Sensitivity Analysis of Groundwater Flow and Transport Models for the Moab Project Site

Letter Report

June 2002

Prepared by
U.S. Department of Energy
Grand Junction Office
Grand Junction, Colorado

Figure 5. Hydraulic Conductivity for SMI Steady-State Model (a) Layer 1, (b) Layer 2, (c) Layer 3, and NRC Steady-State Model (d) Layer 1, (e) Layer 2, (f) Layer 3

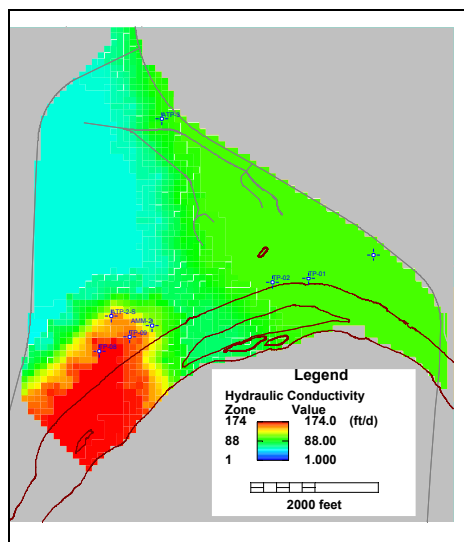
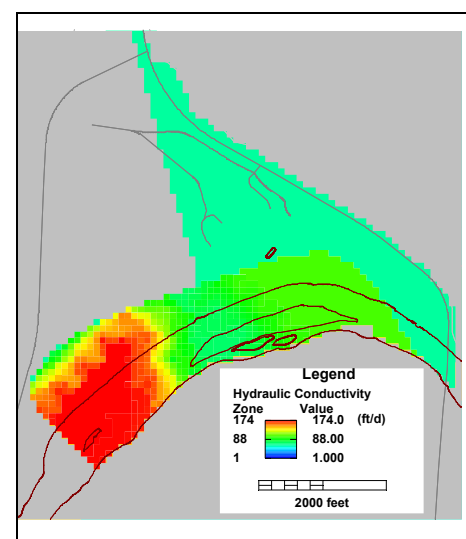
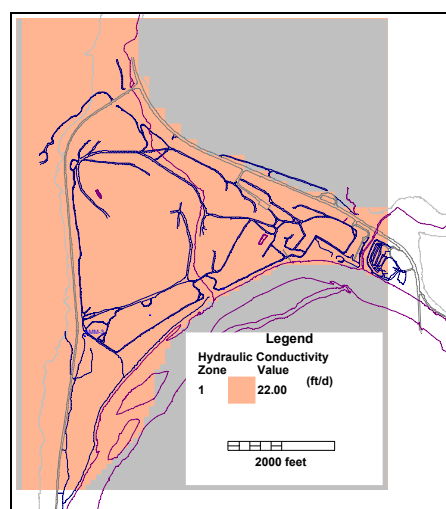
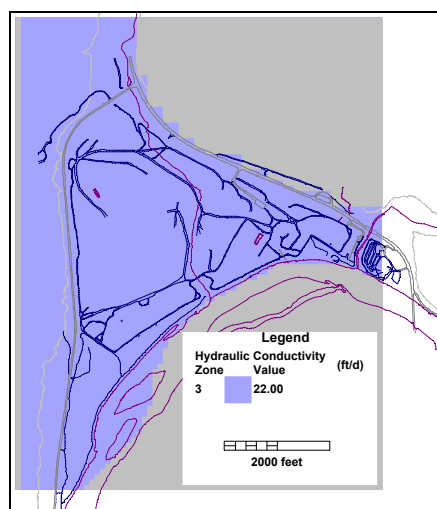
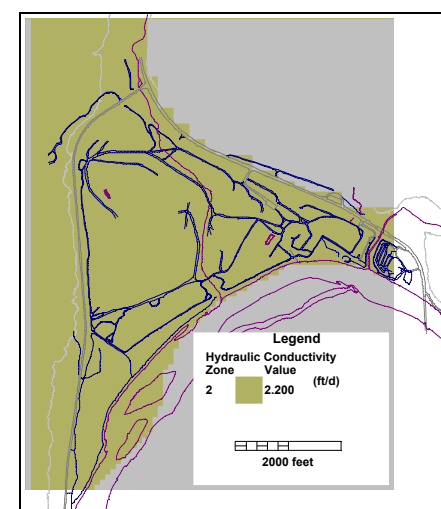
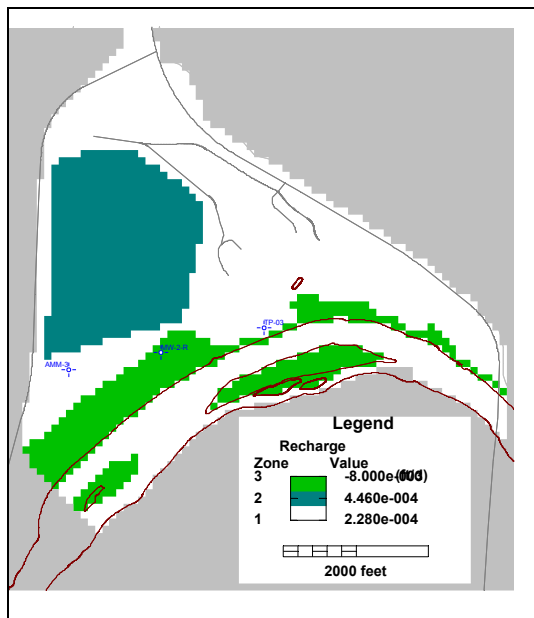
Sensitivity analyses are conducted to identify model parameters and boundary conditions that influence model results. Figures 2 and 5 show that hydraulic conductivity in the SMI model covers a range of 139 individual zones and that the highest hydraulic conductivities occur downgradient of the tailings pile. Many of these hydraulic conductivity zones have such limited areal extent that varying them has little effect on the simulated water levels. This is illustrated in Figure 8 by selecting the five zones with the largest areal extent and evaluating their sensitivity. K zones 35, 49, 50, 60, and 99 (ft/day) each have the five largest areal extents and practically no sensitivity over model outcome. Therefore, zones with smaller areal extent would be even less sensitive.

Figure 7. Simulated Groundwater Contours in Layer 1 of (a) SMI Steady-State Model, and (b) NRC Steady-State Model

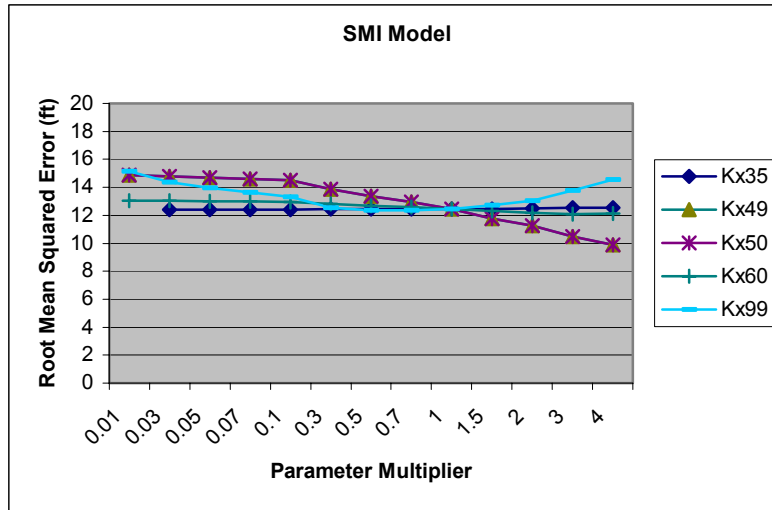
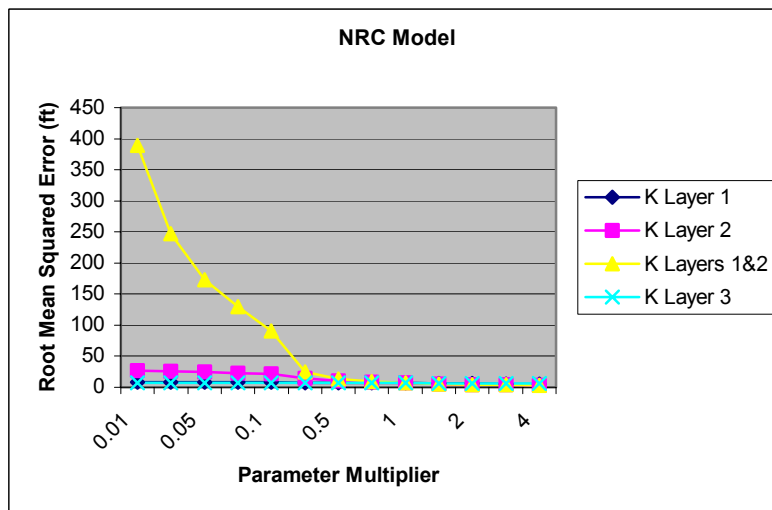
Figure 7 presents the steady-state water level contours for both models. As shown in Figure 7, a large portion of the SMI model contains dry cells in Layer 1. The dry cells probably form because the model cells in Layer 1 are excessively thin and do not intersect the groundwater. Elimination of dry cells in the SMI model would improve overall reliability of the model. The NRC model has no dry cells.

Figure 8. Sensitivity Analysis of Hydraulic Conductivity Parameter for (a) SMI Model and (b) NRC Model

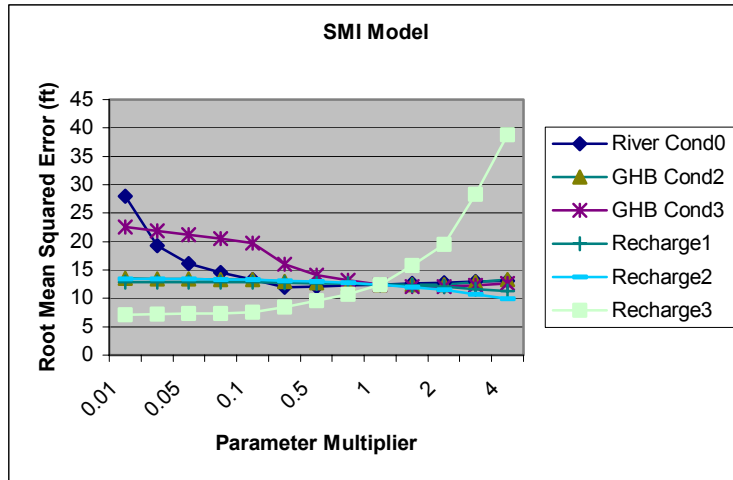
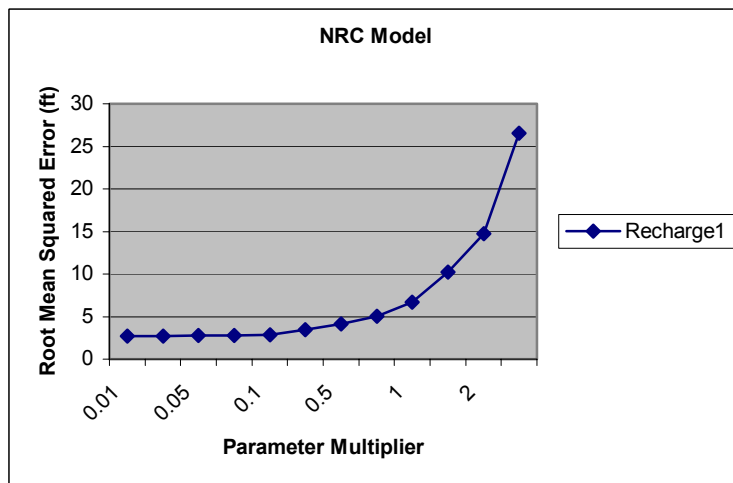
Layers 1 and 2 of the NRC model are each composed of hydraulic conductivity values of $K = 22$ ft/d, while layer 3 is set to 2.2 ft/d. As shown in Figure 8, there is practically no effect on simulated water levels if the hydraulic conductivity of just one layer is varied. However, if the hydraulic conductivity of Layers 1 and 2 is reduced by more than 50 percent, the residual error increases markedly. The absence of a conductive layer is what forces the water table higher when Layers 1 and 2 conductivities are lowered.

Figure 9. Sensitivity Analysis of (a) Boundary Conditions and Recharge for SMI Model and (b) Recharge for NRC Model

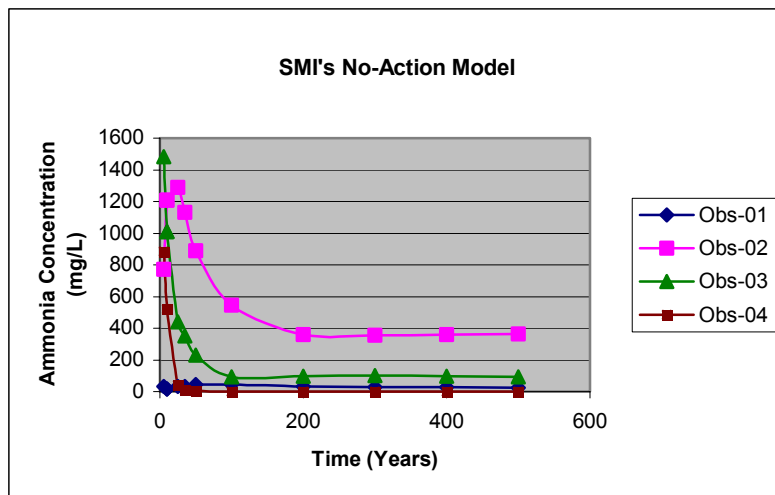
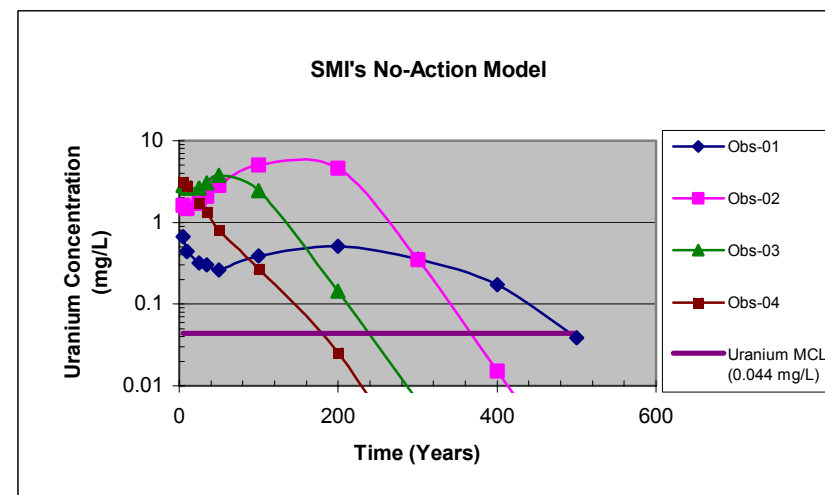
Model sensitivity to recharge and boundary conditions was also evaluated. Figure 9 presents the results of these evaluations for the SMI and NRC models. These analyses show that the SMI model is somewhat sensitive to 10-fold reductions in riverbed conductance in Layer 1 and general-head boundary conductance in Layer 3. In addition, the model is affected by intensifying the negative-recharge parameter that describes the salt cedar community. Figure 9 shows that the NRC model is sensitive to recharge if it increases twofold over the baseline condition.
